Altec Industries, Inc. has developed a product improvement which relates to certain DMB Series, DB41B and DR41B Series derricks built from March through May 2020.

SIL 771

# Service Information Letter

## Circuit Board Inspection

**Figure 2 – BRVD for DMB Series and DR41B**

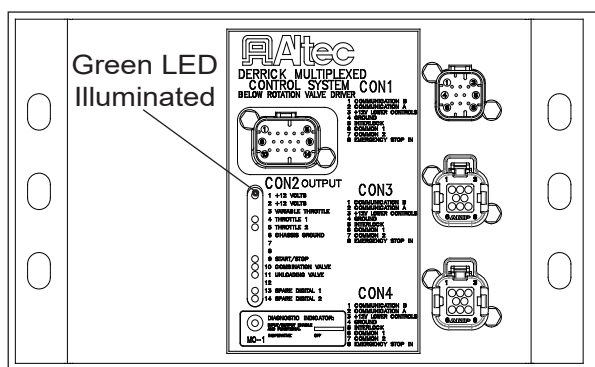
### 6. Look at the BRVD to confirm the status of the +12V LED as shown in the figure listed below.

- For DMB Series or DR41B, refer to Figure 2.
- For DB41B, refer to Figure 3.

- If the LED is not visible, find the BRVD part number shown on its part number tag and mark the corresponding part number in Figure 7 for replacement due to black potting.
- If the LED is illuminated green, the BRVD does not require replacement.

**Figure 4 – ARVD for DMB Series and DB41B**

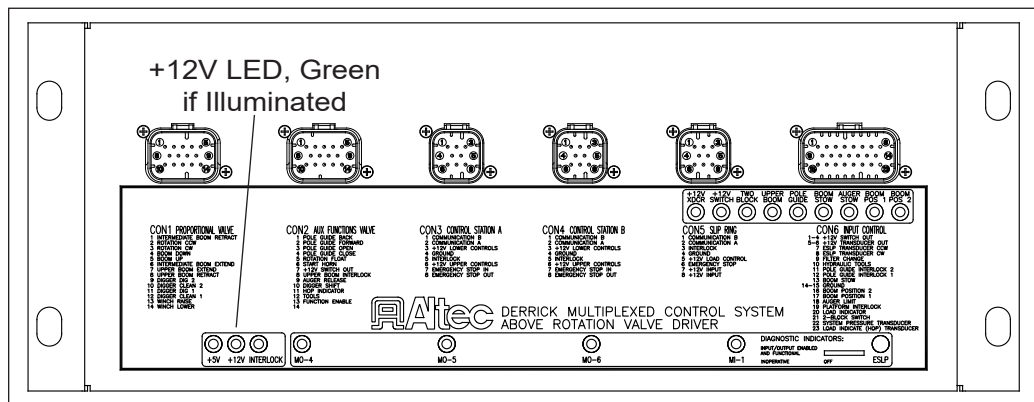
### 12. Look at the ARVD to confirm the status of the +12V LED (refer to Figure 4).

- If the LED is not visible, find the ARVD part number shown on its part number tag and mark the corresponding part number in Figure 7 for replacement due to black potting.
- If the LED is illuminated green, the ARVD does not require replacement.

**Figure 5 – CBB for DMB Series**

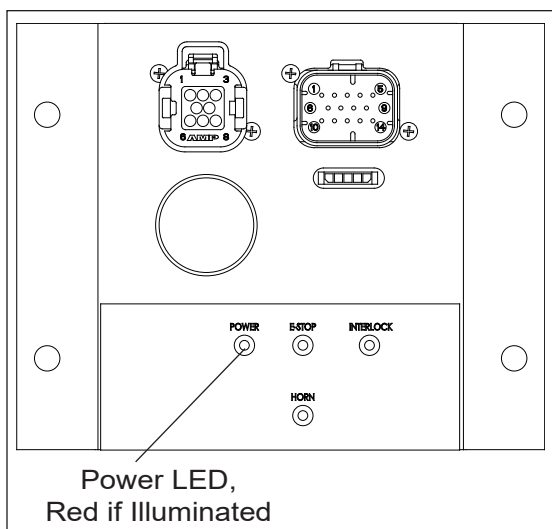
### 18. Look at the CBB to confirm the status of the Power LED as shown in the figure listed below.

- For DMB Series, refer to Figure 5.
- For DB41B, refer to Figure 6.

- If the LED is not visible, find the CBB part number shown on its part number tag and mark the corresponding part number in Figure 7 for replacement due to black potting.
- If the LED is illuminated red, the CBB does not require replacement.
